**TOWN OF MOUNTAIN VILLAGE  
REGULAR DESIGN REVIEW BOARD MEETING  
AGENDA THURSDAY MARCH 31, 2022 10:00 AM  
MOUNTAIN VILLAGE TOWN HALL  
455 MOUNTAIN VILLAGE BLVD, MOUNTAIN VILLAGE, COLORADO  
TO BE HELD HYBRID THROUGH ZOOM:**

AGENDA ITEM 3  
**PLANNING & DEVELOPMENT SERVICE**  
**PLANNING DIVISION**  
455 Mountain Village Blvd.  
Mountain Village, CO 81435  
(970) 728-1392

**Case Summary:** Ken Alexander of Architects Collaborative (Applicant) on behalf of Westport Holding Texas LP, the owner of Lot AR-53R1 is requesting Design Review Board (DRB) approval of an Initial Architectural and Site Review (IASR) Application for a new single-family detached condominium at TBD Adams Way. The existing conditions plan provided by Foley and Associates indicates that Unit AR-53R1 is 6,110 square feet in size. The Village at Adams Ranch is a single-family condominium community and is zoned Multi-Family. The overall square footage of the home is approximately 4,778 gross square feet, with 4,005 livable square feet, and provides two interior parking spaces within the proposed garage and an additional two exterior spaces.

SHEET  
A3.1  
Unit AR-53R1

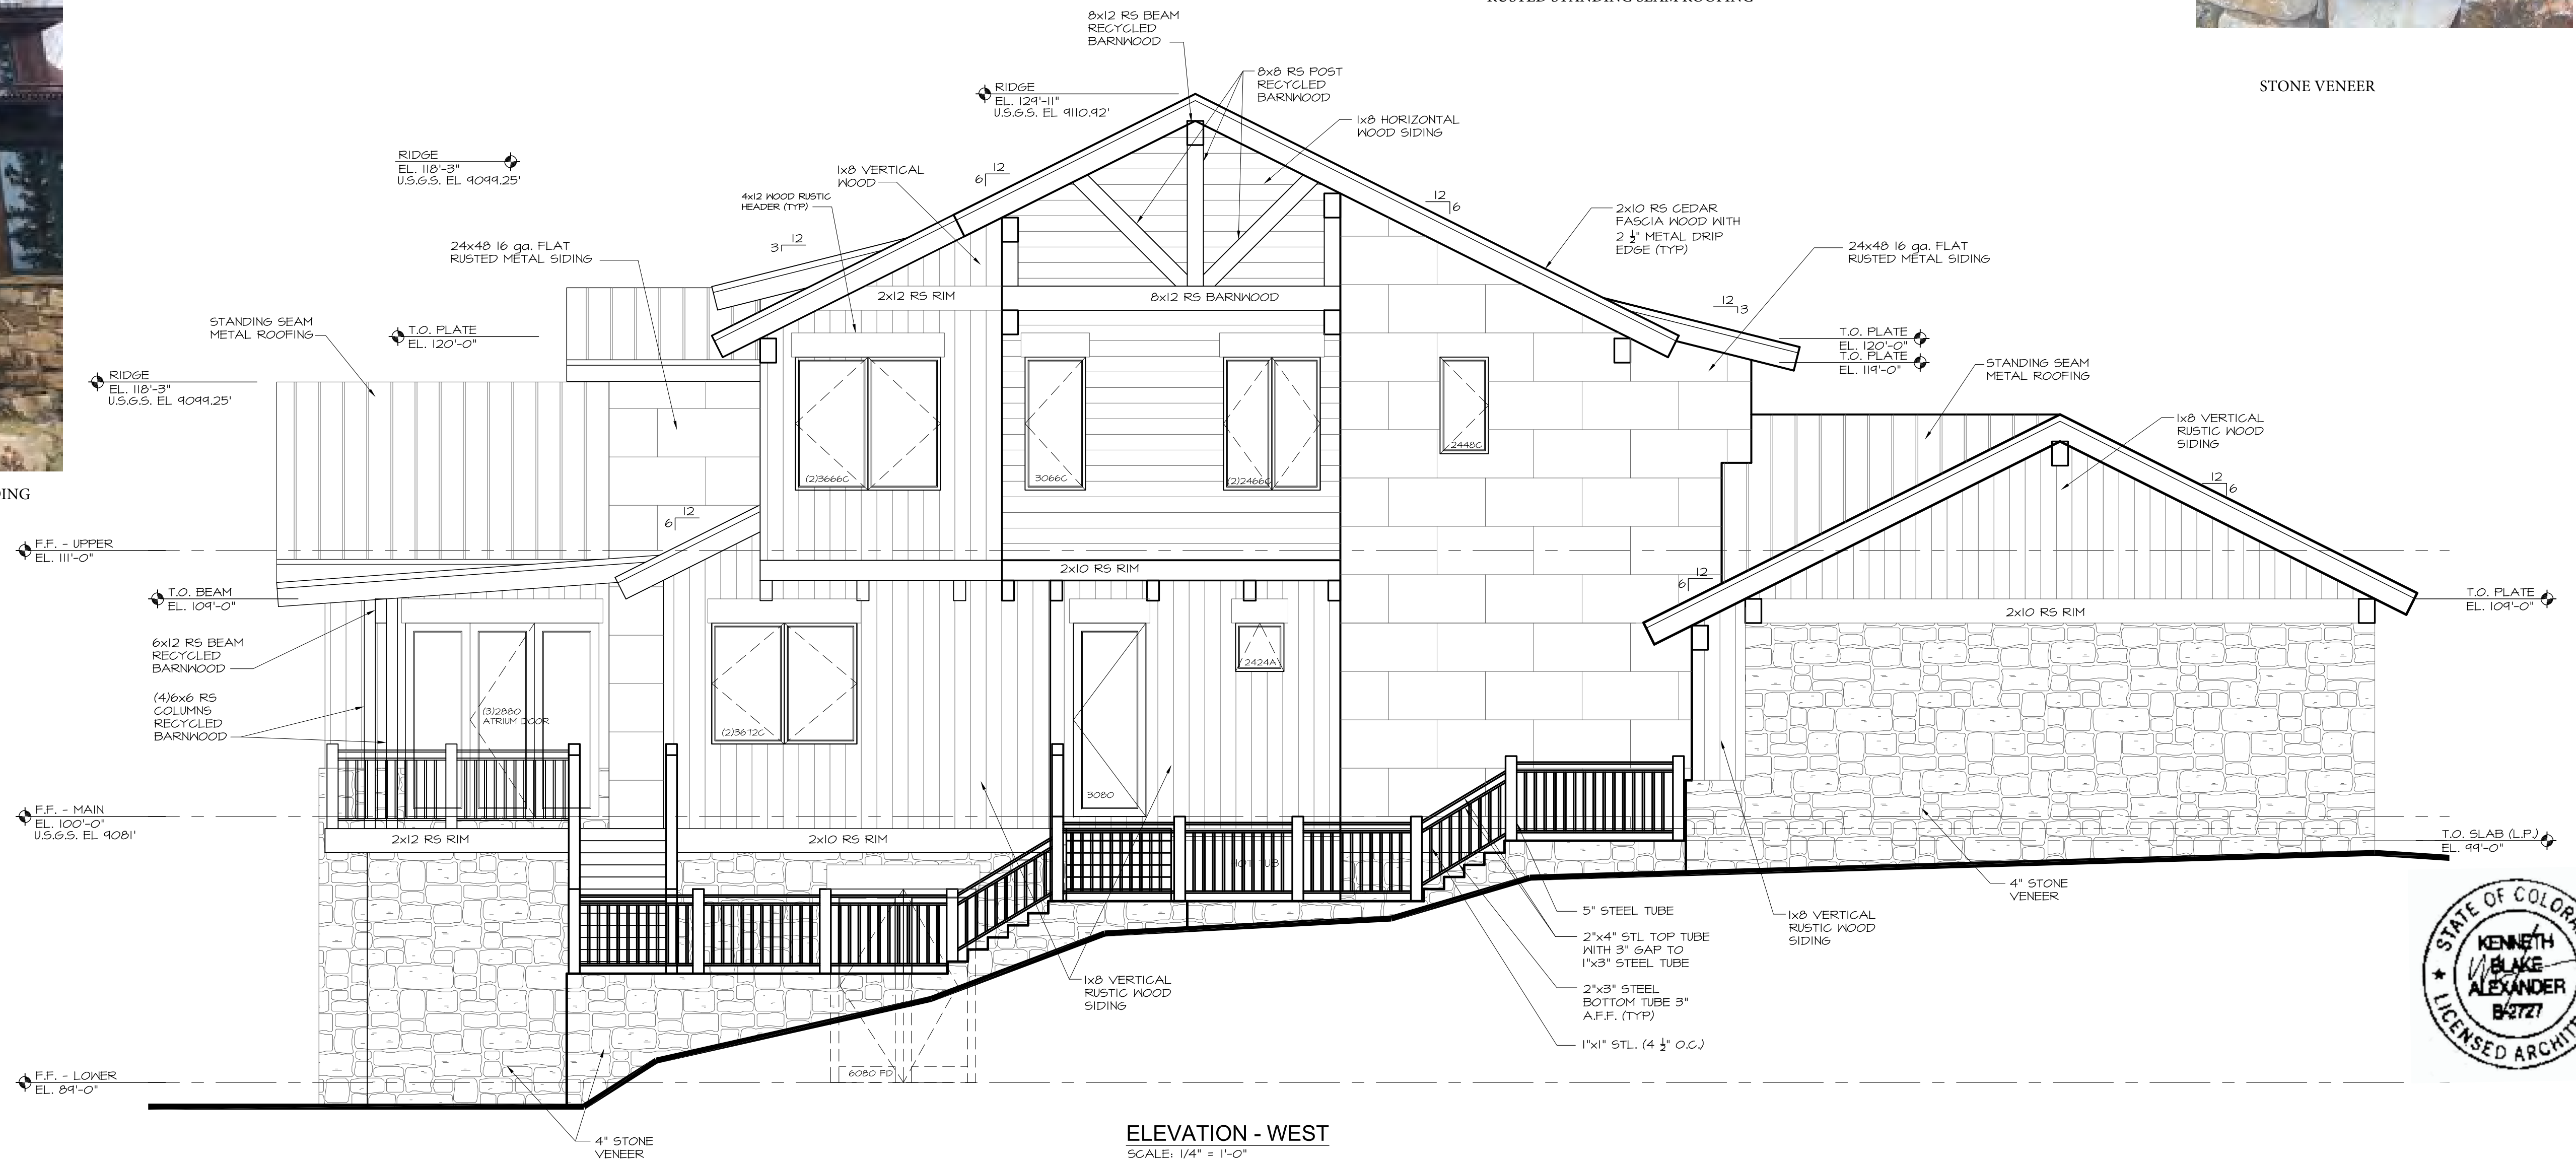
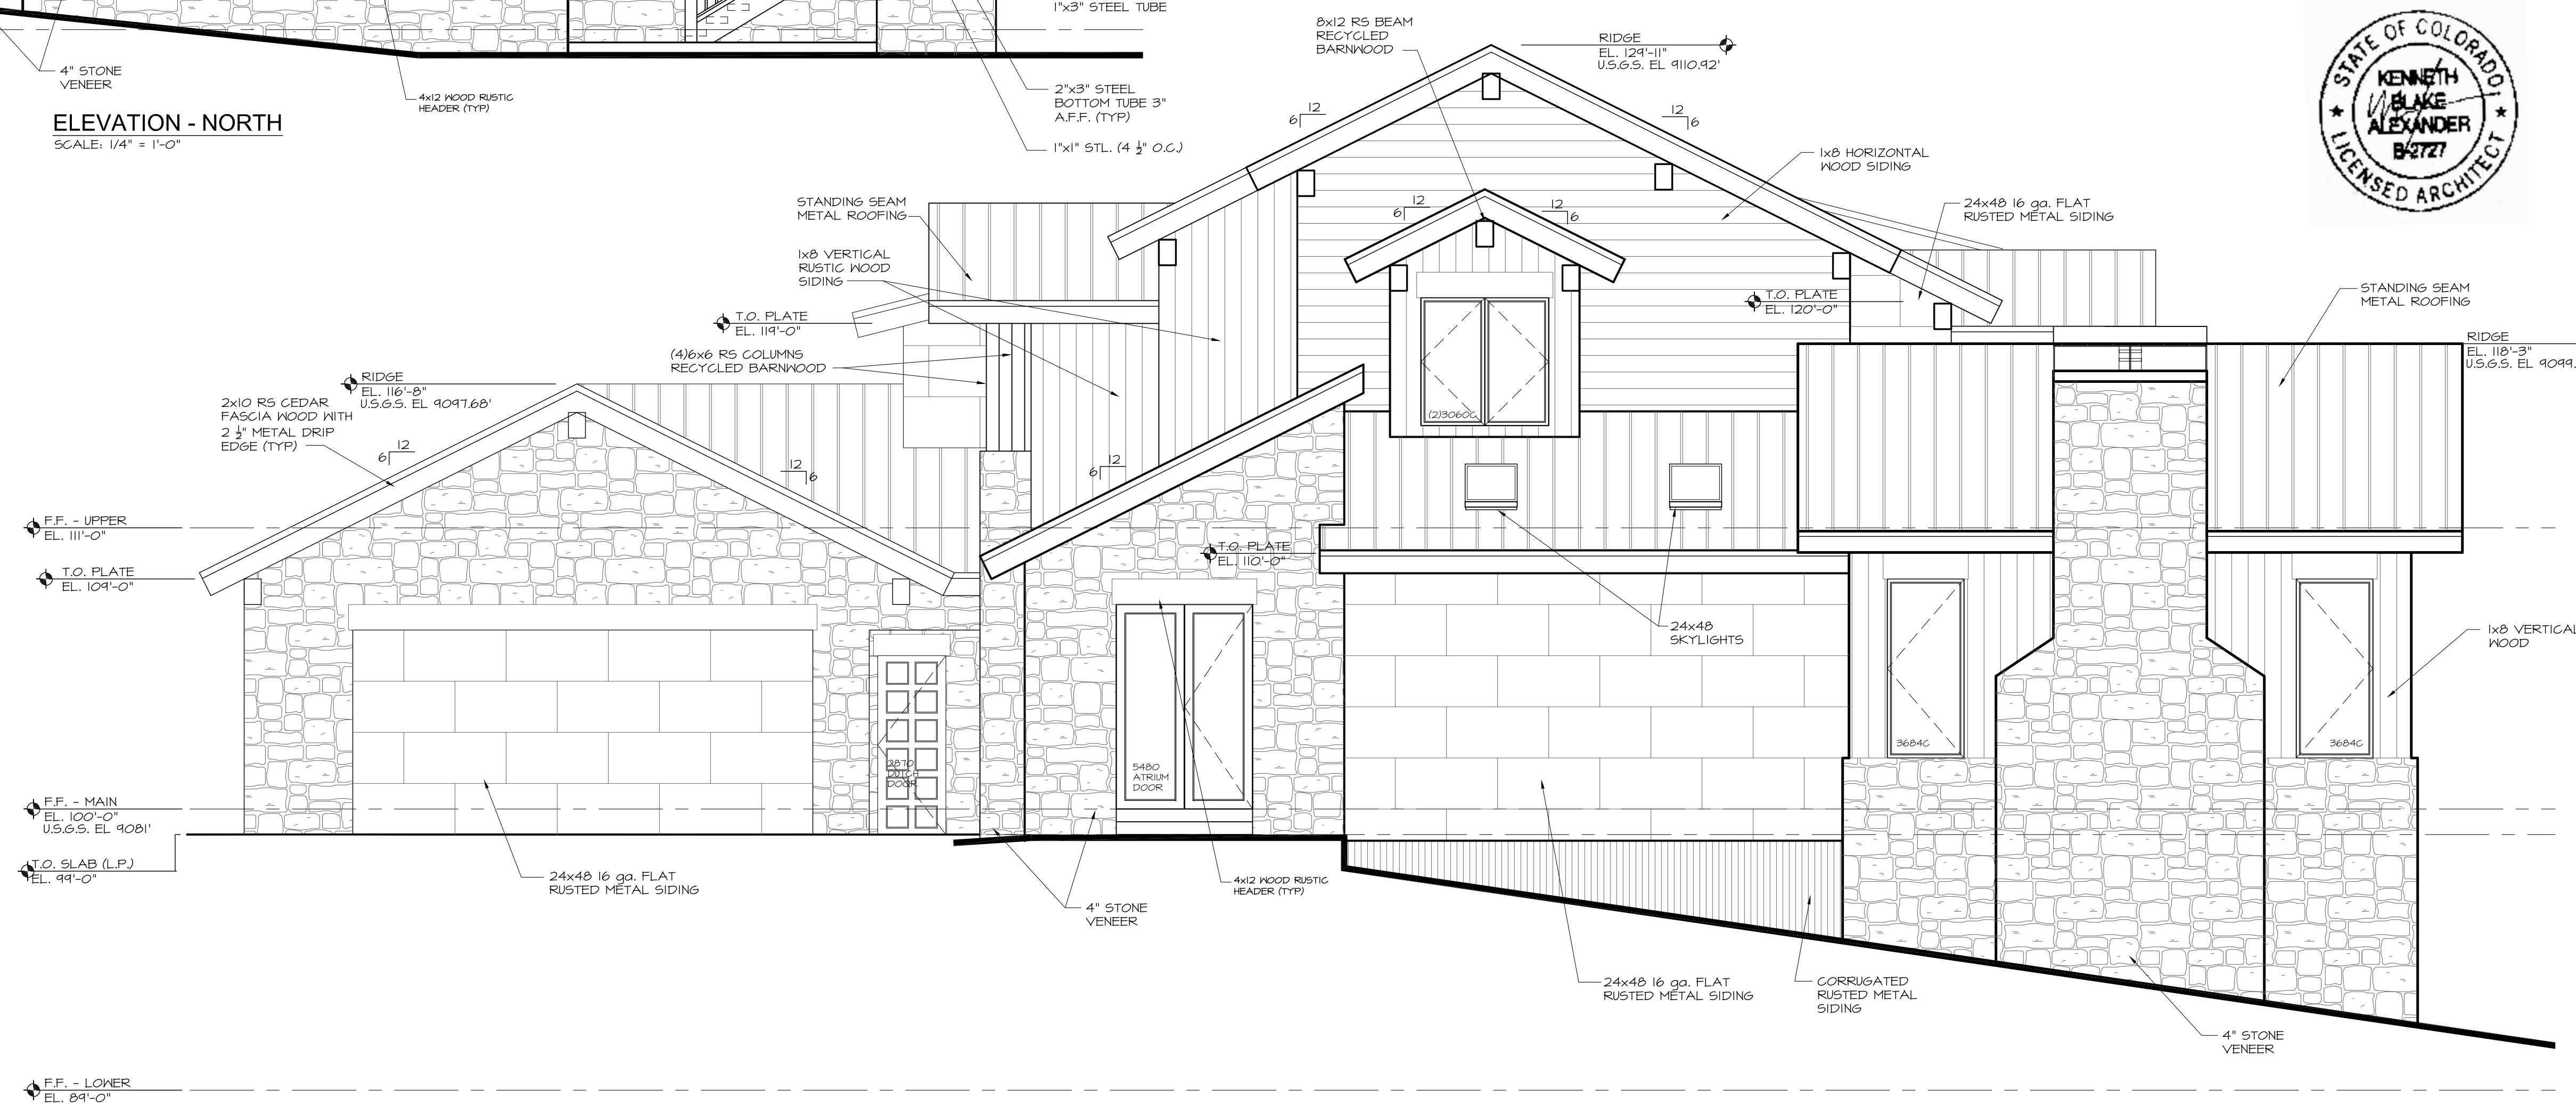
The window frames indicated on the submission (Drawing A3.2) are exterior clad fiberglass. In the CDC, Section 17.5.6, Building Design, under Section G, Glazing, #8, it states, “Window frames and trim shall be painted or stained wood, anodized, painted or clad aluminum or patina copper clad.” Fiberglass clad windows are not mentioned.

- 1) Prior to final review, the applicant shall provide updated height elevations due to issues with the digital document quality.
- 2) Prior to final review, the applicant shall revise the proposed windows to meet the requirements of the CDC.
